# Access Compliance Report

### (Curb Ramps)

Intersection ID: 13882	Main Street: BARCLIFF_DR	Cross Street: FARM_POND_LN	Location: S
ADA ID: E2FC06330D44	Ramp Type: Perp	Initial Pass/Fail: Fail	Overall Compliance: No
Codes/Mitigation Info/Possible Solution		Field Measurements/Component Compliance	
Severity Score: 21.25

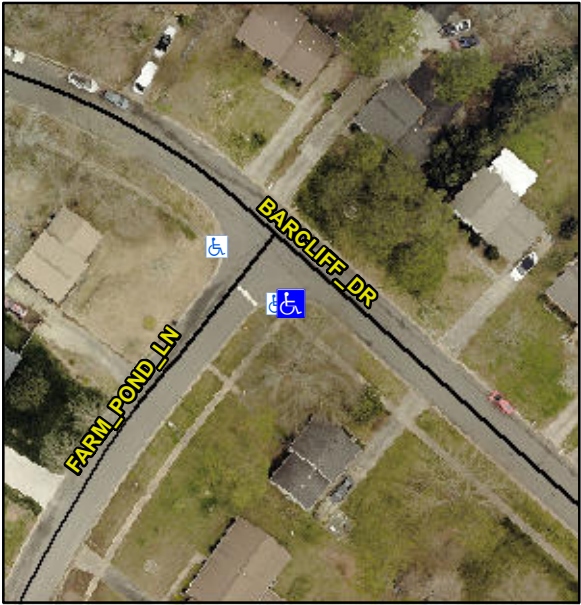
Possible Solutions:						
	Remove & Replace Entire Ramp.						
	Surveyor Notes:						
	N/A						
	PROW/ADA:						
	Not Found, R304.5.1, R304.5.3						
Street 1 Name	BARCLIFF DR	Compliance	Description	Data	Compliance	Description	Data
Stop Condition-Street 2	None	N/A	Ramp Length (in)	51.5	Yes	Ramp Slope (%)	5.5
Street 2 Name	N/A	No	Ramp Width (in)	44.0	No	Ramp XSlope (%)	6.1
Stop Condition-Street 1	N/A	N/A	Flare Type LT	N/A	N/A	Flare Type RT	N/A
		N/A	Flare Slope LT (%)	N/A	N/A	Flare Slope RT (%)	N/A
		N/A	Flare Traversable LT?	N/A	N/A	Flare Traversable RT?	N/A
		N/A	Landing Length (in)	N/A	N/A	DWS Provided?	N/A
		N/A	Landing Width (in)	N/A	N/A	DWS Contrast?	N/A
		N/A	Landing Slope (%)	N/A	N/A	DWS Length (in)	N/A
		N/A	Landing X Slope (%)	N/A	N/A	DWS Full Width?	N/A
		N/A	Landing Curb? (Y/N)	N/A	N/A	DWS Offset (in)	N/A
		N/A	Shared Landing?	N/A			
		N/A	Gutter Ponding?	N/A	N/A	Gutter Slope (%)	N/A
		N/A	Gutter Lip Ht (in)	N/A	N/A	Gutter X Slope (%)	N/A

N/A	Painted X Walk1?	No	N/A	Painted X Walk2?	N/A
			X Walk 1 Direction	To NE		X Walk 2 Direction	N/A
		N/A	X Walk 1 Width (in)	N/A	N/A	X Walk 2 Width (in)	N/A
			X Walk 1 Slope (%)	2.2		X Walk 2 Slope (%)	N/A
			X Walk 1 X Slope (%)	5.4		X Walk 2 X Slope (%)	N/A
		N/A	Ramp inside XWalk1?	N/A	N/A	Ramp inside XWalk2?	N/A
			Road Slope (%)	5.4	N/A	Clear Space?	N/A
			Road X Slope (%)	2.2	N/A	Clear Space to XWalk (in)	N/A
		N/A	Any Obstructions?	N/A	N/A	Storm Grate/Utility Hazard?	N/A
			Obstruction Type			Storm Grate/Utility Type	
				N/A			N/A
					Yes	Surface Condition? (G/P)	Good
Total Cost:		\$ 1850.00
